Access Compliance Report

Public Rights-of-Way

(Curb Ramps)

Intersection ID: N/A	Main Street: MONROE_RD	Cross Street: PRINCESS_ANN_DR	Location: SW
ADA ID: 528D7A119DA3	Ramp Type: PerpDiag	Initial Pass/Fail: Fail	Overall Compliance: No
Severity Score: 12.5			
Codes/Mitigation Info/Possible Solution		Field Measurements/Component Compliance

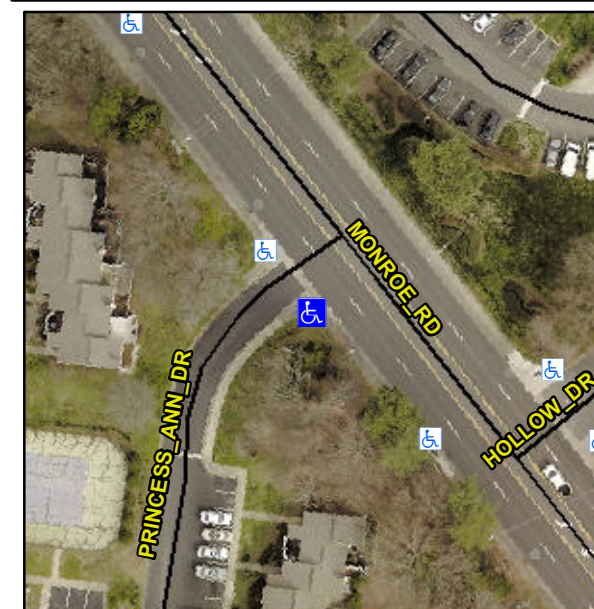
Not Found, R304.2.2

Compliance	Description	Data	Compliance	Description	Data
N/A	Ramp Length (in)	61.0	No	Ramp Slope (%)	9.9
Yes	Ramp Width (in)	48.0	Yes	Ramp XSlope (%)	1.7
N/A	Flare Type LT	N/A	N/A	Flare Type RT	N/A
N/A	Flare Slope LT (%)	N/A	N/A	Flare Slope RT (%)	N/A
N/A	Flare Traversable LT?	N/A	N/A	Flare Traversable RT?	N/A
N/A	Landing Length (in)	N/A	N/A	DWS Provided?	N/A
N/A	Landing Width (in)	N/A	N/A	DWS Contrast?	N/A
N/A	Landing Slope (%)	N/A	N/A	DWS Length (in)	N/A
N/A	Landing X Slope (%)	N/A	N/A	DWS Full Width?	N/A
N/A	Landing Curb? (Y/N)	N/A	N/A	DWS Offset (in)	N/A
N/A	Shared Landing?	N/A			
N/A	Gutter Ponding?	N/A	N/A	Gutter Slope (%)	N/A
N/A	Gutter Lip Ht (in)	N/A	N/A	Gutter X Slope (%)	N/A
N/A	Painted X Walk1?	No	N/A	Painted X Walk2?	No
	X Walk 1 Direction	To NE		X Walk 2 Direction	To NW
N/A	X Walk 1 Width (in)	N/A	N/A	X Walk 2 Width (in)	N/A
	X Walk 1 Slope (%)	0.9		X Walk 2 Slope (%)	3.0
	X Walk 1 X Slope (%)	1.5		X Walk 2 X Slope (%)	2.3

Remove & Replace Curb Ramp With Two New Directional Ramps or Equivalent.
